## HISTORIC AND DESIGN REVIEW COMMISSION

**HDRC CASE NO:** 2016-349  
**ADDRESS:** 401 E HOUSTON ST  
**LEGAL DESCRIPTION:** NCB 417 BLK 19 CIR 6 & W 1.1 FT OF 5 ARB A1  
**ZONING:** D HS  
**CITY COUNCIL DIST.:** 1  
**LANDMARK:** Burns Building, Washer Bros Building  
**APPLICANT:** Mike McGlone/Alamo Architects  
**OWNER:** Blauners - Houston, L.P.  
**TYPE OF WORK:** Addition, exterior modification  
**REQUEST:**

BURNS - PENNY BUILDING RENOVATION / ADDITION

**Historic and Design Review Commission  
Design Review Committee  
Report & Recommendation**

1. Typical Existing Building Floor Plan (levels 2, 3 and 4)
2. Typical Addition Floor Plan (levels 4, 5, 6 and 7)
3. Exterior Elevations West and South
4. Perspective View with annotation of the existing 5<sup>th</sup> floor that is being demolished.

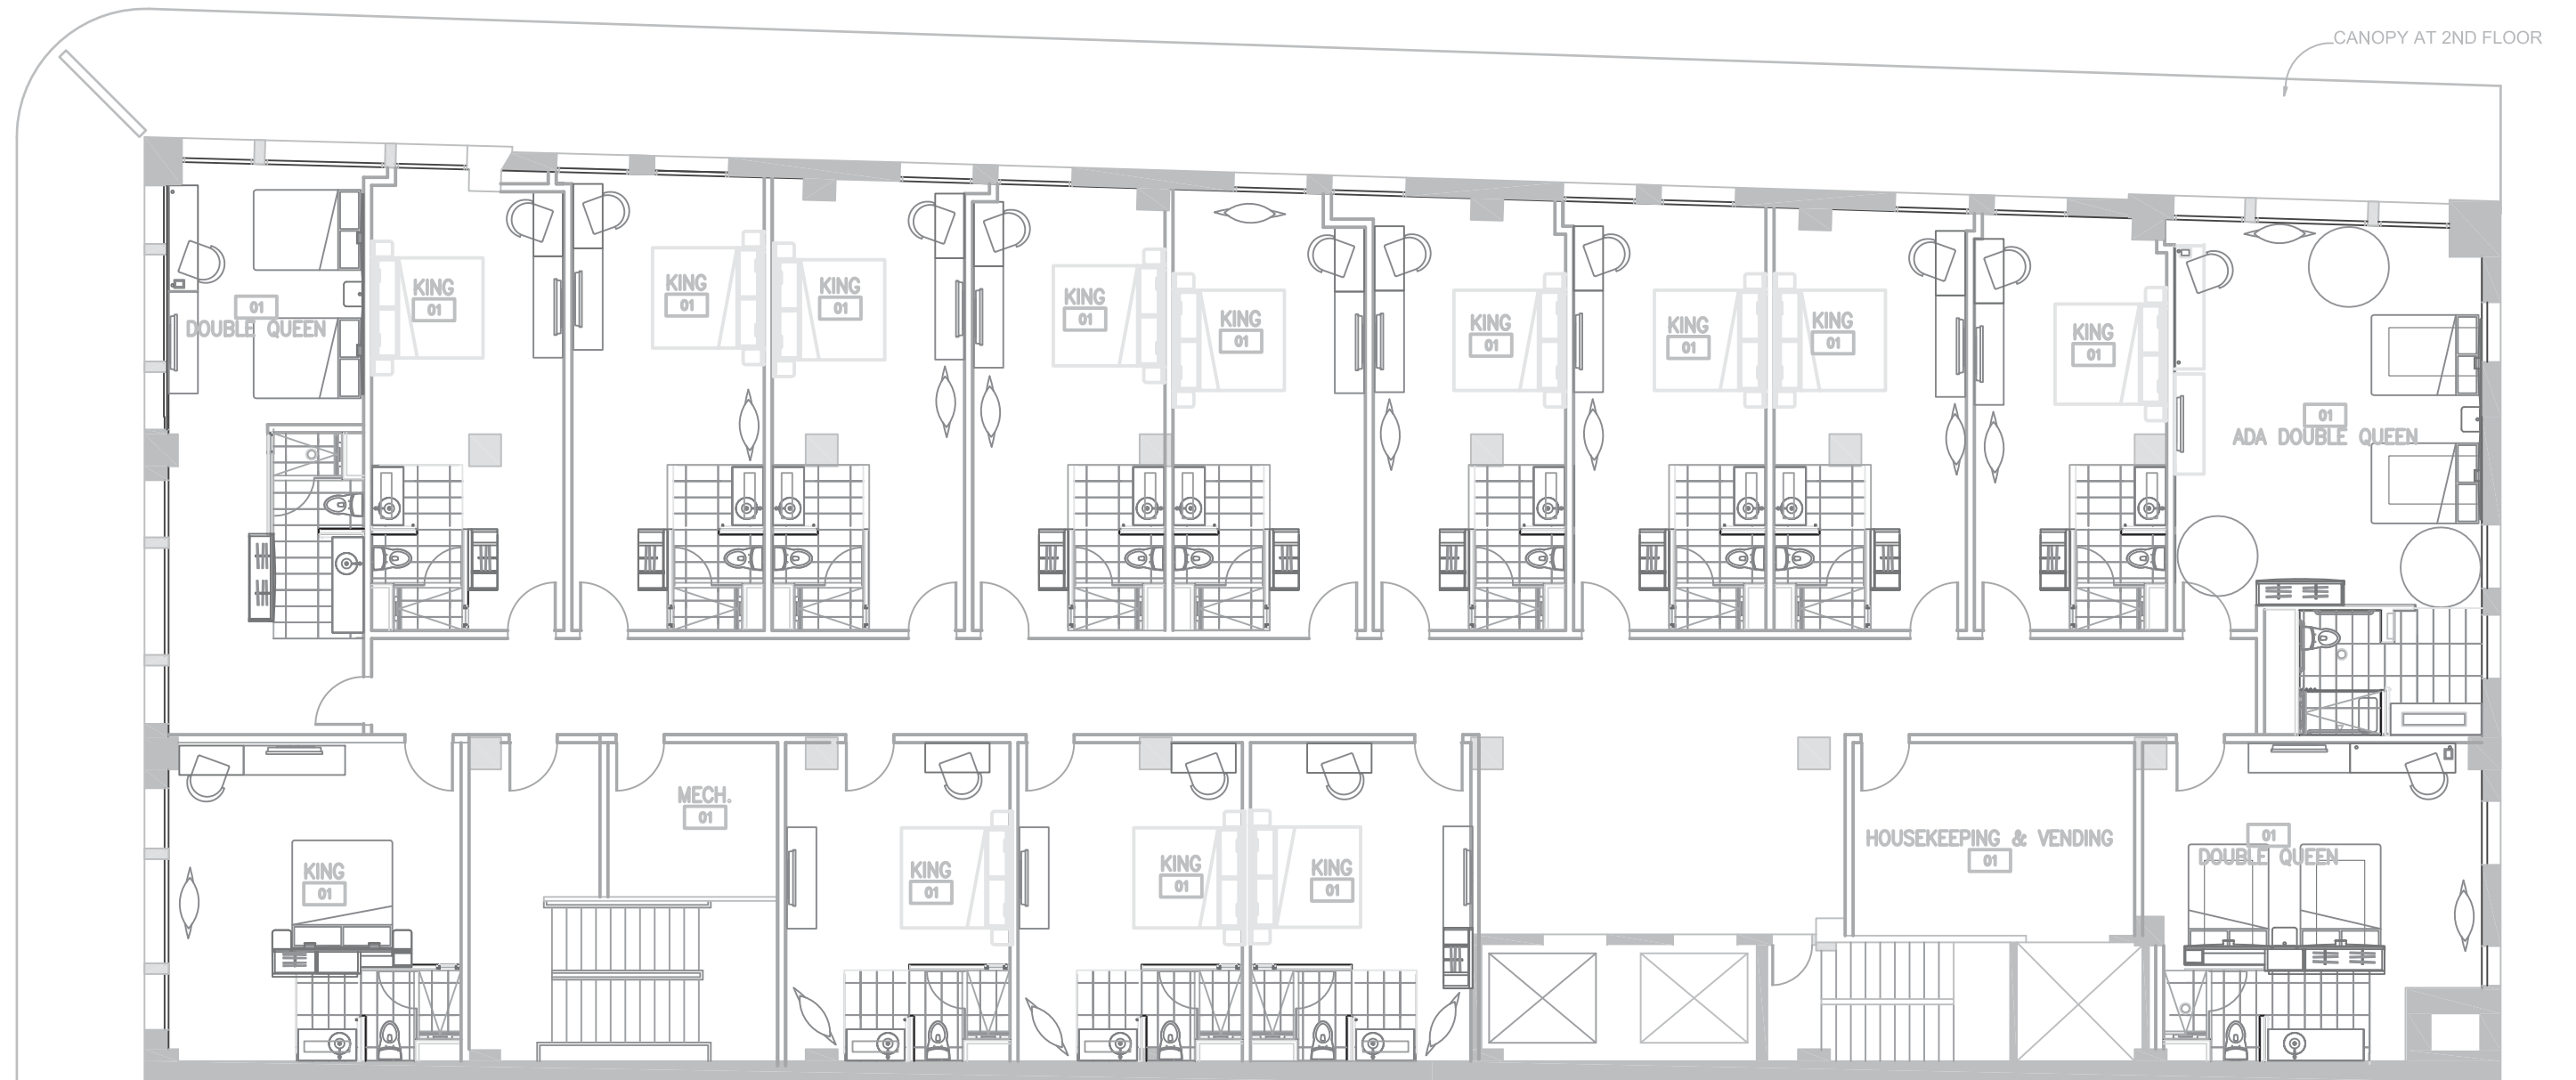
IC: A DIAGRAM NOTING CURRENT AND PROPOSED IN ONE PERSPECTIVE  
WOULD BE HELPFUL. RETURNING TO THE HARC WITH UPDATED

CONCEPTUAL DOCUMENTS SHOULD BE A PRIORITY. QUESTIONS REGARDING

AN UPDATED SETBACK. TL: PROPOSED LAP SEEMS HEAVY, CONSIDER

REDUCING DEPTH AND WEIGHT, KB: CONSIDER A TAPER OR TRIMMING OF  
LAP.

Per our meeting with the HDRC Architectural Committee on Wednesday, September 28<sup>th</sup> we intend to present an updated Concept Design to the HDRC on October 19<sup>th</sup>. Based on the commissioners comments and discussion we have made modifications to the current design and are enclosing the following:

401. E. HOUSTON ST. / FLOORS 5, 6, 7, 8  
SCALE 3/32" = 1' - 0"

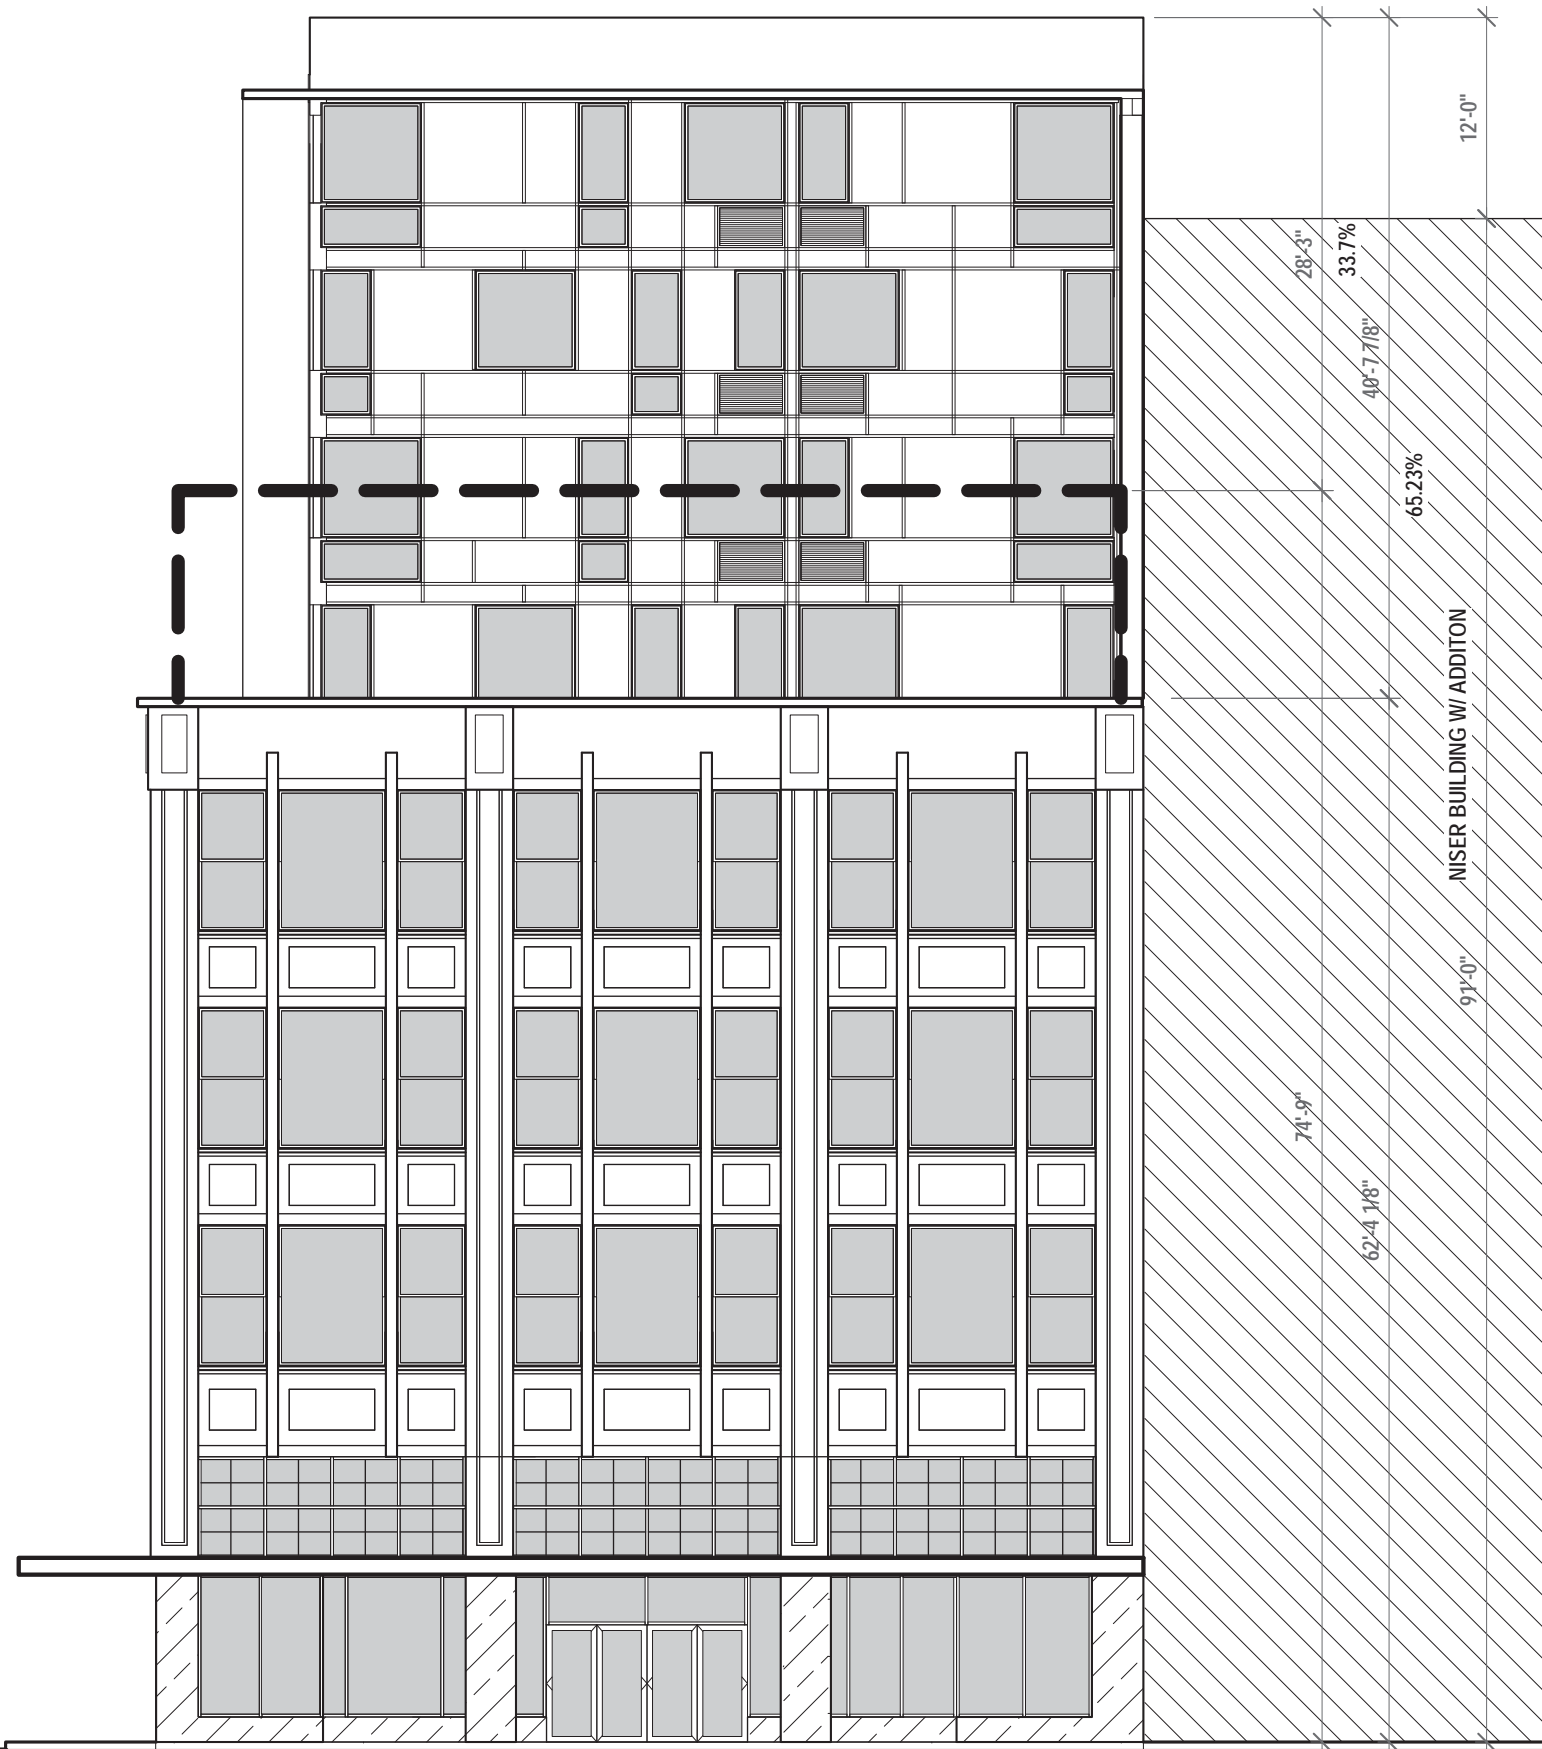
- g. **ADDITION** – At the rooftop of the original structure, the applicant has proposed to construct an addition to feature four floors; each featuring a floor to floor height of ten (10) feet. According to the Guidelines for Additions 2.A. new additions should be designed to be in keeping with the existing, historic context of the block, should be sited to minimize the visual impact on the original structure, should utilize a similar roof form, should be subordinate to the principle façade and should feature a transition between the old and new. The applicant has proposed to set back the proposed addition nine (9) feet from the south façade and approximately 9' – 6" from the

west façade which tapers to a setback of 3' – 4" at the northwest corner of the addition given the irregular footprint of the historic structure. Staff finds that this will limit new massing at the corner of E Houston and Jefferson and work to preserve historic street views along both streets. Additionally, the applicant has proposed floor to ceiling height that are subordinate to that of the original structure and has proposed materials that will distinguish between the original structure and the proposed addition. Staff finds this consistent with the Guidelines.

- h. **SCALE, MASSING & FORM** – According to the Guidelines for Additions, 2.B., the height of rooftop additions should be limited to no more than forty (40) percent of the height of the original structure. Full floor rooftop additions that obscure the form of the original structure are not appropriate. The height of the original structure is approximately sixty-two (62) feet in height. The applicant has proposed the addition to feature approximately forty-one (41) feet in height; approximately sixty-six (66) percent of the historic structure's height. When including the existing addition, the existing overall height is approximately seventy-five (75) feet in height. A total new net height proposed at this location is approximately twenty-eight (28) feet in height, approximately thirty-seven (37) percent of the existing height. Staff finds that the proposed addition's massing and height will not obscure the form of the original structure and is consistent with the height found on this block of E Houston.
